ENGINEERING SERVICES SPATIALS

47359_ESP_01 - 461 Chapel Road, Bankstown

Date 23.01.2025 - Revision 1

PROJECT
**461 CHAPEL ROAD, BANKSTOWN, NSW
 2200**
 DRAWING TITLE
**ENGINEERING SERVICES SPATIALS -
 ROOF**

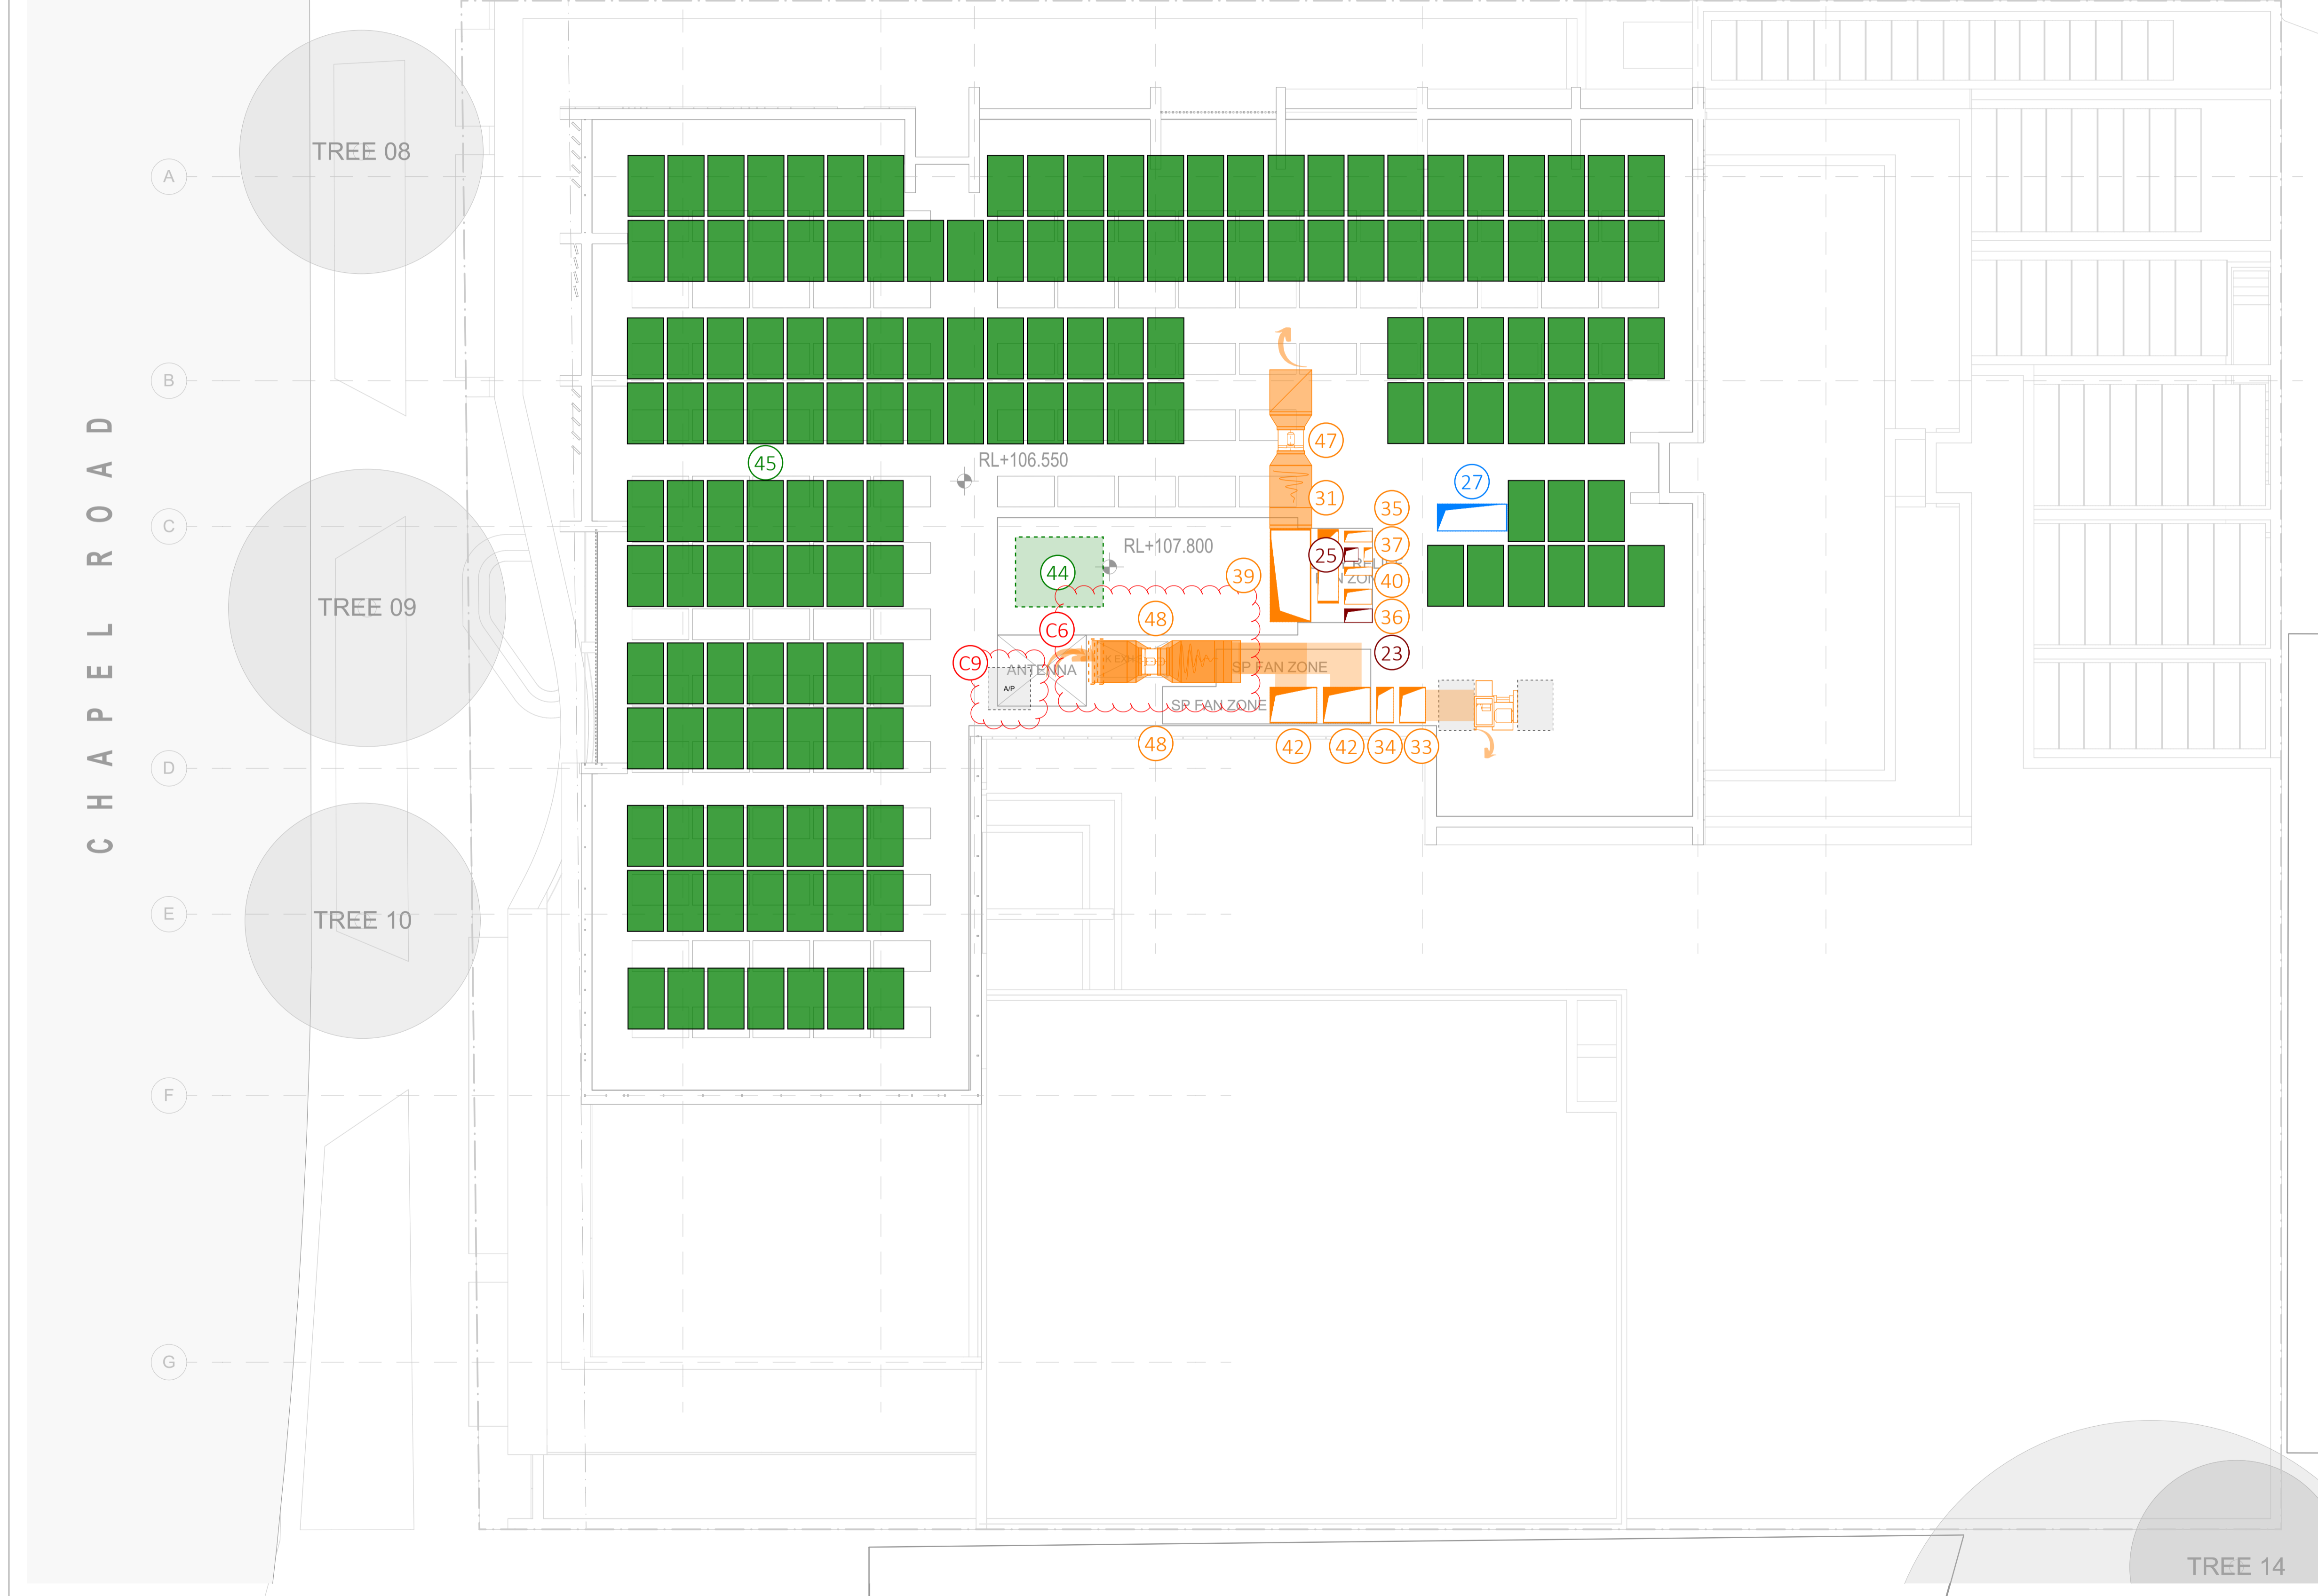
Action Reference No.	Action	Issue Status
C1	Egress around fire tanks is under review. Columns to be revised as indicated. We recommend relocating the OSD tank to allow for the fire tank arrangement as shown.	Open
C2	Columns in switch room to be reviewed. If columns need to remain, the switch room may need to get deeper.	Open
C3	Egress design compliance to be confirmed. We recommend having a direct egress path to the fire control room from outside, to be confirmed by BCA.	Open
C4	We recommend allowing for traffic bollards around the substation due to the proximity to the vehicle travel path.	Open
C5	Carpark exhaust fans to be located at high level. To be coordinated with waste room layout and garbage chute locations.	Open
C6	Stair pressurisation fans to be stacked as shown.	Open
C7	Carpark intake to be coordinated with landscaping in communal outdoor space.	Open
C8	Plant to be reviewed by acoustics to determine acoustic treatment required for space. Intent for plant space to be open to above to allow for ventilation to plant.	Open

C9	Access to roof to have integrated ladder complete with handrail. We recommend egress paths to rooftop to be reviewed by BCA.	Open
C10	No built form is permitted above kiosk substations. To retain substations as kiosk type, extent of building to be reviewed.	Open
C11	900mm clear trench is required below the kiosk to allow for HV feeder from authority connection, and between kiosk and main switch room. This will result in a low head height area as shown.	Open
C12	Cupboards are required to transition on level to connect to basement level. Transition and riser location to be coordinated with architecture	Open
C13	Anything within the 3m radius of the kiosk substations is required to be blast proof. Location and extent of roller shutter door to be reviewed to ensure this is not within the blast radius.	Open
